Access Compliance Report

Public Rights-of-Way

Intersection ID: 3583	Main Street: ARDEN_GATE_LN	Cross Street: TREYMORE_LN	Location: S
ADA ID: B7286A8A78AA	Ramp Type: Perp	Initial Pass/Fail: Fail	Overall Compliance: No
		Severity Score: 12.5

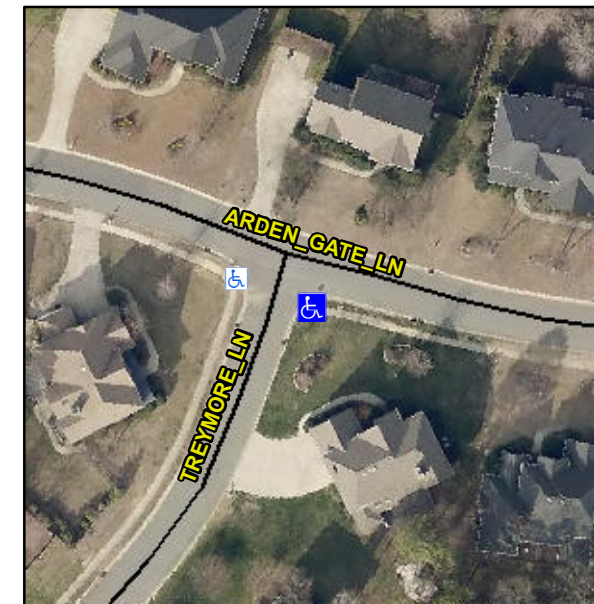
Not Found, R304.5.3

Compliance	Description	Data	Compliance	Description	Data
N/A	Ramp Length (in)	47.0	Yes	Ramp Slope (%)	7.3
Yes	Ramp Width (in)	48.0	No	Ramp XSlope (%)	6.9
N/A	Flare Type LT	N/A	N/A	Flare Type RT	N/A
N/A	Flare Slope LT (%)	N/A	N/A	Flare Slope RT (%)	N/A
N/A	Flare Traversable LT?	N/A	N/A	Flare Traversable RT?	N/A
N/A	Landing Length (in)	N/A	N/A	DWS Provided?	N/A
N/A	Landing Width (in)	N/A	N/A	DWS Contrast?	N/A
N/A	Landing Slope (%)	N/A	N/A	DWS Length (in)	N/A
N/A	Landing X Slope (%)	N/A	N/A	DWS Full Width?	N/A
N/A	Landing Curb? (Y/N)	N/A	N/A	DWS Offset (in)	N/A
N/A	Shared Landing?	N/A			
N/A	Gutter Ponding?	N/A	N/A	Gutter Slope (%)	N/A
N/A	Gutter Lip Ht (in)	N/A	N/A	Gutter X Slope (%)	N/A
N/A	Painted X Walk1?	No	N/A	Painted X Walk2?	N/A
	X Walk 1 Direction	To NW		X Walk 2 Direction	N/A
N/A	X Walk 1 Width (in)	N/A	N/A	X Walk 2 Width (in)	N/A
	X Walk 1 Slope (%)	3.9		X Walk 2 Slope (%)	N/A
	X Walk 1 X Slope (%)	2.6		X Walk 2 X Slope (%)	N/A

Remove & Replace Entire Ramp.
